Amendment No. 0001  
19 December 2003

SUBJECT: Amendment No. 0001 to Request for Proposal Solicitation Package  
for Design and Construction of REPLACE CENTRAL FIRE ALARM SYSTEM, PN 3378,  
IOWA AAP, IOWA.

Solicitation No. DACA45 03 R 0034.

SKETCH SKG4.03  
ELECTRICAL LEGEND

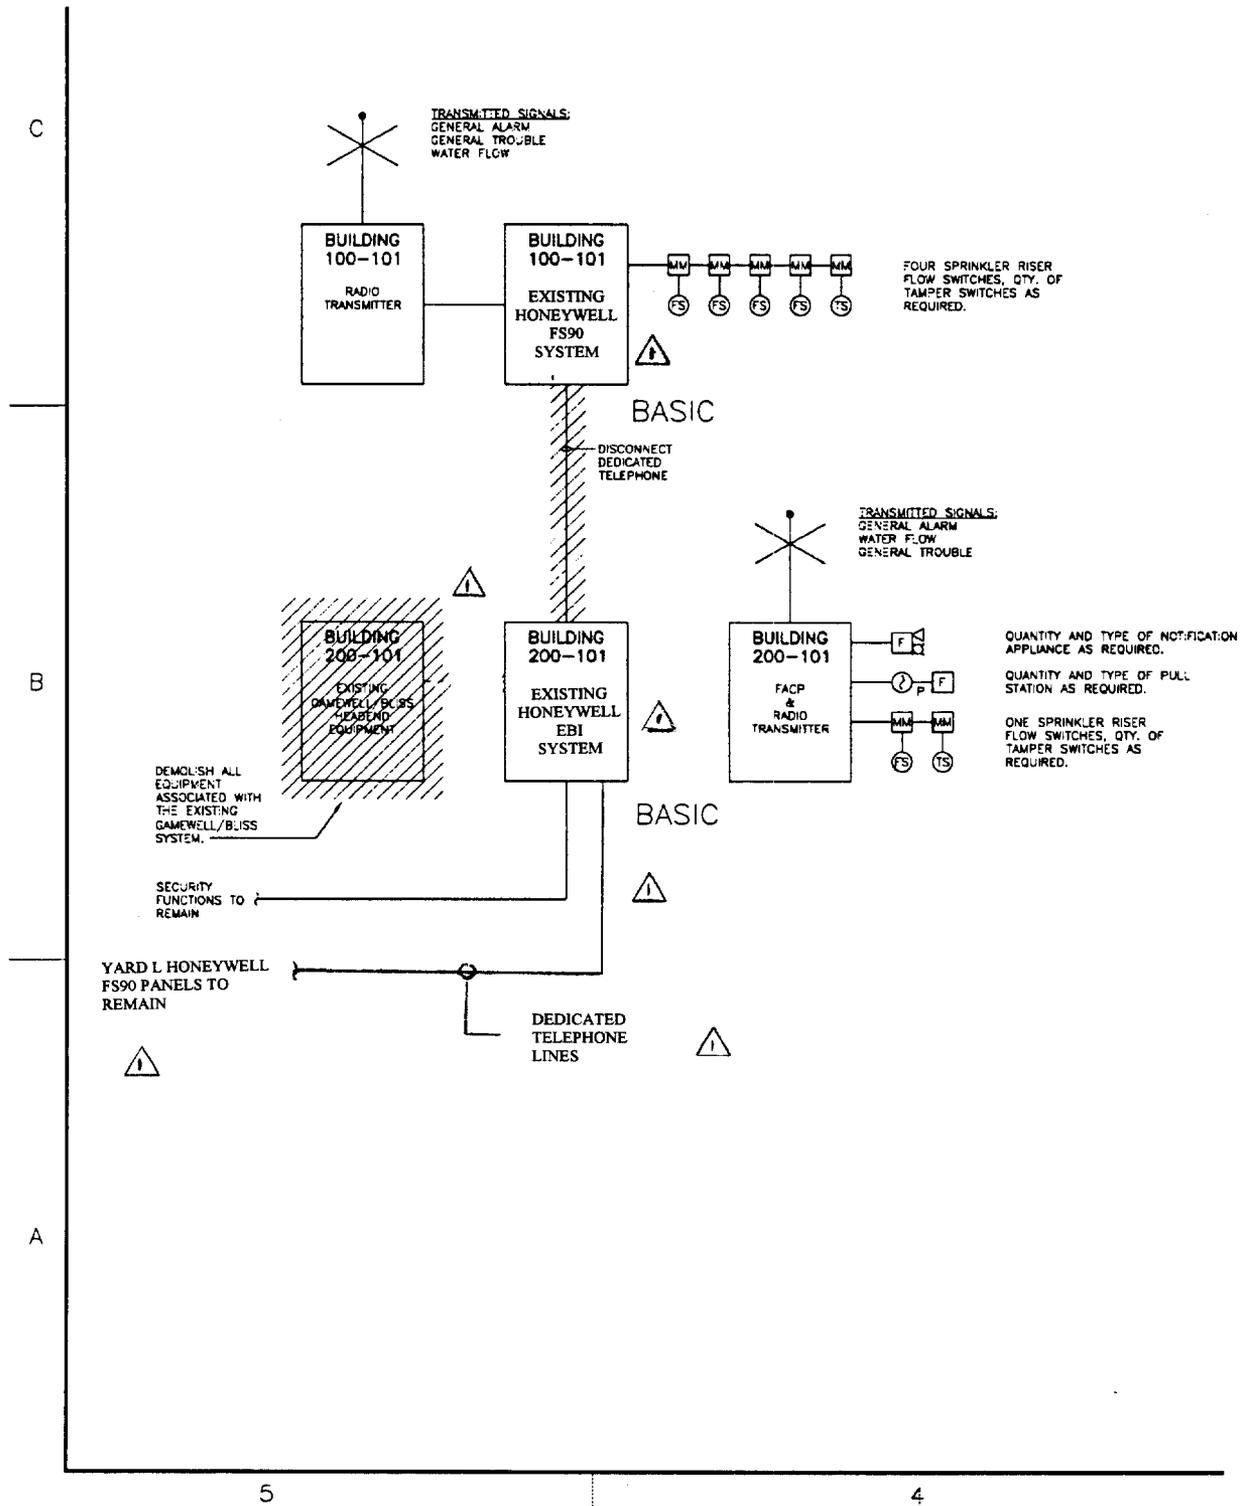
(1) Sheet G4.03, revise 4<sup>th</sup> column on the right of the legend sheet in accordance with attached Sketch SKG4.03.
